Access Compliance Report

Public Rights-of-Way

(Curb Ramps)

Intersection ID: 4938	Main Street: BAUCOM_RD	Cross Street: CARMATHEN_RD	Location:	N
ADA ID: 8B183A5795D8	Ramp Type: Perp	Initial Pass/Fail: Fail	Overall Compliance: No	Severity Score: 8.75
Codes/Mitigation Info/Possible Solution		Field Measurements/Component Compliance

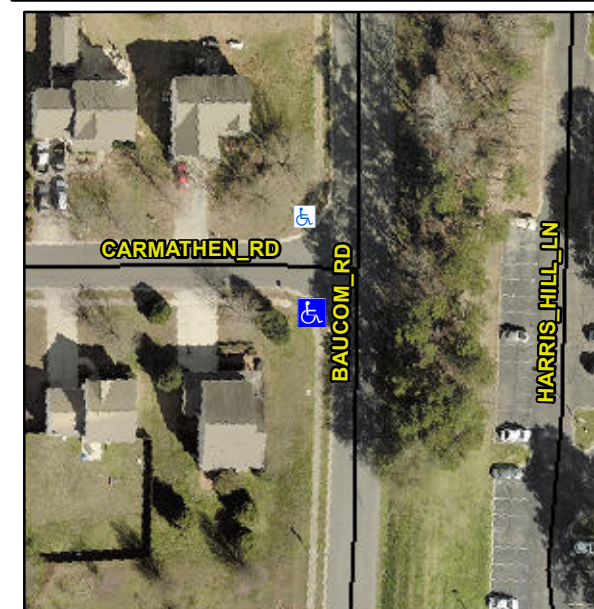
Not Found, R304.5.1

Compliance	Description	Data	Compliance	Description	Data
N/A	Ramp Length (in)	48.0	Yes	Ramp Slope (%)	7.5
No	Ramp Width (in)	39.0	Yes	Ramp XSlope (%)	1.8
N/A	Flare Type LT	N/A	N/A	Flare Type RT	N/A
N/A	Flare Slope LT (%)	N/A	N/A	Flare Slope RT (%)	N/A
N/A	Flare Traversable LT?	N/A	N/A	Flare Traversable RT?	N/A
N/A	Landing Length (in)	N/A	N/A	DWS Provided?	N/A
N/A	Landing Width (in)	N/A	N/A	DWS Contrast?	N/A
N/A	Landing Slope (%)	N/A	N/A	DWS Length (in)	N/A
N/A	Landing X Slope (%)	N/A	N/A	DWS Full Width?	N/A
N/A	Landing Curb? (Y/N)	N/A	N/A	DWS Offset (in)	N/A
N/A	Shared Landing?	N/A			
N/A	Gutter Ponding?	N/A	N/A	Gutter Slope (%)	N/A
N/A	Gutter Lip Ht (in)	N/A	N/A	Gutter X Slope (%)	N/A
N/A	Painted X Walk1?	No	N/A	Painted X Walk2?	N/A
	X Walk 1 Direction	To SW		X Walk 2 Direction	N/A
N/A	X Walk 1 Width (in)	N/A	N/A	X Walk 2 Width (in)	N/A
	X Walk 1 Slope (%)	0.6		X Walk 2 Slope (%)	N/A
	X Walk 1 X Slope (%)	1.7		X Walk 2 X Slope (%)	N/A

Remove & Replace Entire Ramp.
